# Reliability Analysis Update

Transmission Expansion Advisory Committee

March 9, 2021

# Dominion Transmission Zone: Baseline Idylwood to Tysons & Tysons Substation

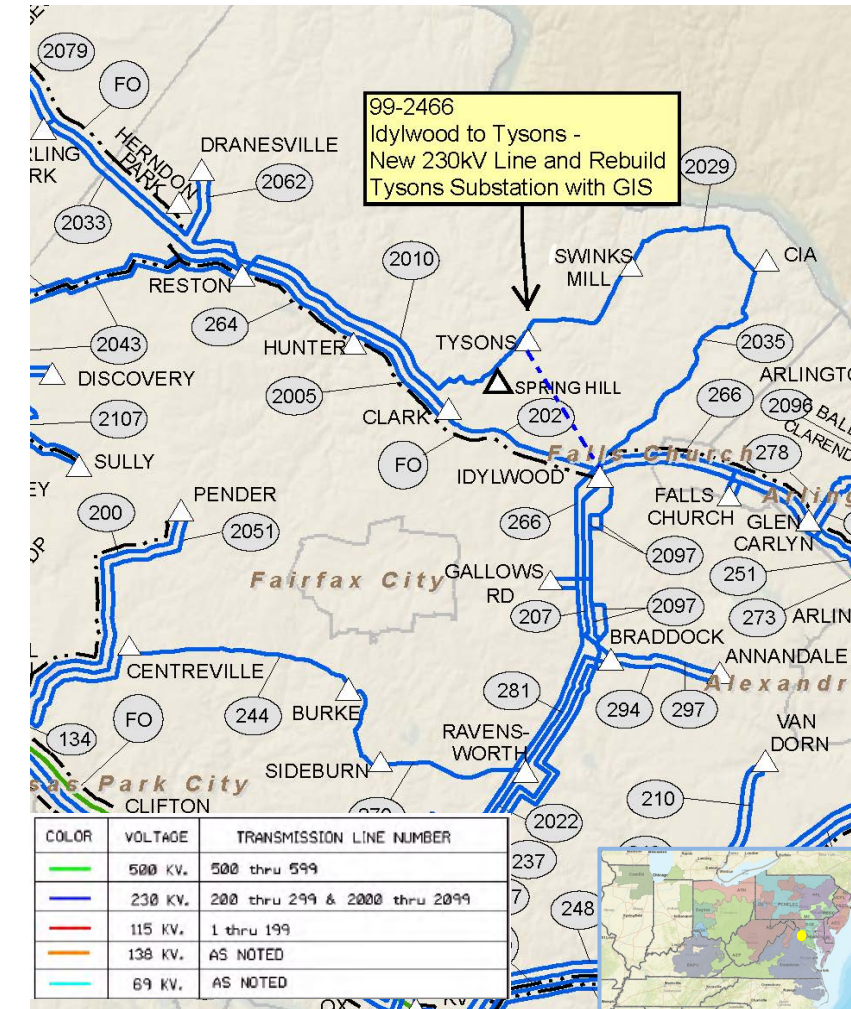
**Revised: Idylwood to Tysons 230kV Line and Rebuild Tysons with GIS**

## Problem Statement:

- N-1-1 loss of Line #2010 (Reston-Tysons) and Line #2035 (Idylwood-CIA) results in the loss of more than 300 MW (NERC Category P6 - Multiple Contingency – Two overlapping singles).

- Construct a 230kV UG line approx. 4.5 miles from Idylwood to Tysons. Tysons Substation will be rebuilt, within its existing footprint, with a 6-breaker ring bus using GIS equipment.
- Rebuild Tysons Sub and convert Tysons substation to GIS equipment.
- **Est. Total Cost \$111.7M**
- **Revised Est. Total Cost \$181.8M**

- Engineering (**Est. cost increase \$2M**)
- Materials (**Est. cost increase \$4M**)
- Construction bid – Site prep at Tysons (**Est. cost increase \$5.3M**)
- Construction bid – UG line work (**Est. cost increase \$19.14M**)
- Delay charges for civil and HDD contractors due to permits, local approvals, and communications (**Est. cost increase 6.3M**)
- Nighttime work required by VDOT permitting requirements (**Est. cost increase \$16.5M**)

# Dominion Transmission Zone: Baseline Idylwood to Tysons & Tysons Substation

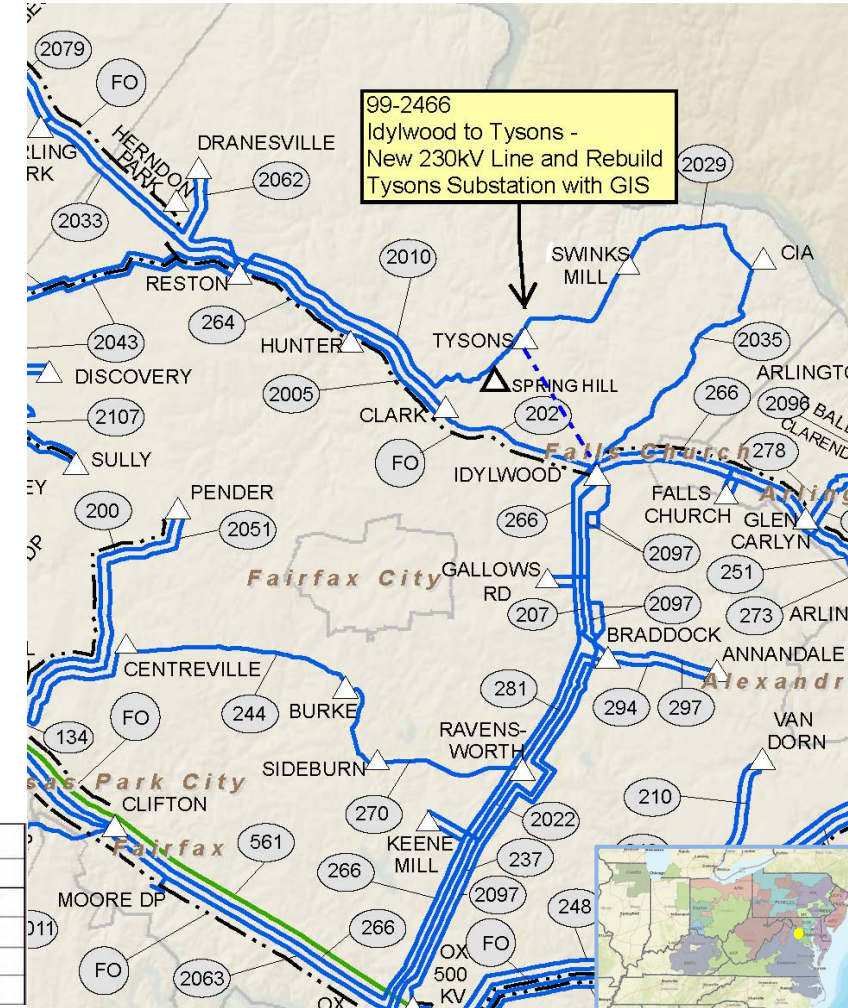
Revised: Idylwood to Tysons 230kV Line and Rebuild Tysons with GIS

- Re-routing W&OD Trail. (Est. cost increase \$0.81M)
- VDOT required monitor of HDD (Est. cost increase \$0.85M)
- Increase in AFUDC (Est. cost increase \$14.3M)
- Additional substation work at Idylwood and Reston (Est. cost increase \$0.91M)

- **Total cost increase (Est. cost increase \$70.1M)**

Revised Projected IS Date: 12/31/2022
